SERVICE BULLETIN AMATEUR RADIO

SUBJECT TM-731A/631A 144MHZ FINAL BOARD C17 CHANGE	DATE .08/08/90
---	-------------------

FIGURE 1

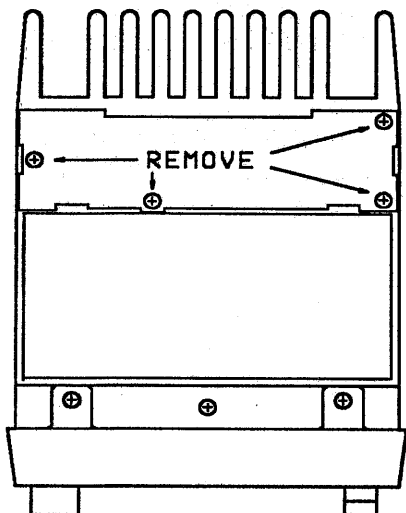
1. Disconnect the power supply and antenna.
2. Remove the top cover. Do not damage the speaker wires.
3. Remove the shield plate from the VHF Final unit (4 screws). **Figure 1**
4. Remove the 7 screws that secure the final board to the chassis. **Figure 2**
5. Remove the 2 screws that secure the power module to the chassis. **Figure 2**
6. Remove the 2 screws that secure the VHF antenna coax to the heat sink.
7. Desolder the center conductor and shield of the VHF antenna coax from the final board and pull the coax out of the heat sink. **Figure 2**
8. Desolder the terminal next to pin 3 of the power module. **Figure 2**
9. Rotate the board toward the front of the transceiver to expose the foil side of the board.
10. Inspect the solder at the terminals the antenna coax was soldered to. They may need to be resoldered.
11. Replace C17. **Figure 3**

FIGURE 3

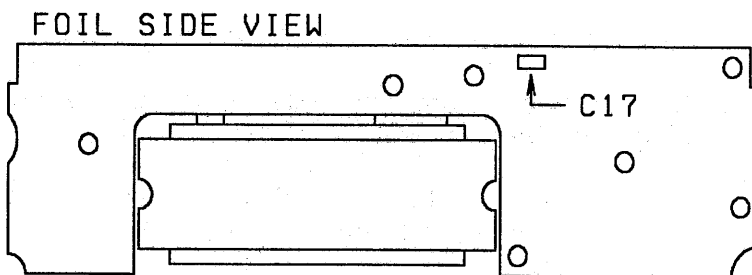
Bypass capacitor C17 on the 144MHz Final board has been changed in production from a "flat package" chip capacitor to a "cylindrical package". The change prevents the capacitor from fracturing. If C17 fractures, the output of the power module can burn C17, R11, and L6. Additionally, Q1 on the TX/RX (144MHz) board may be damaged.

C17 should be changed as a part of routine maintenance when a TM-731A/631A is received for service. The new style capacitor part number is CK41FY1E102M. For field service, a 0.001uF, 25V disc ceramic capacitor can be used.
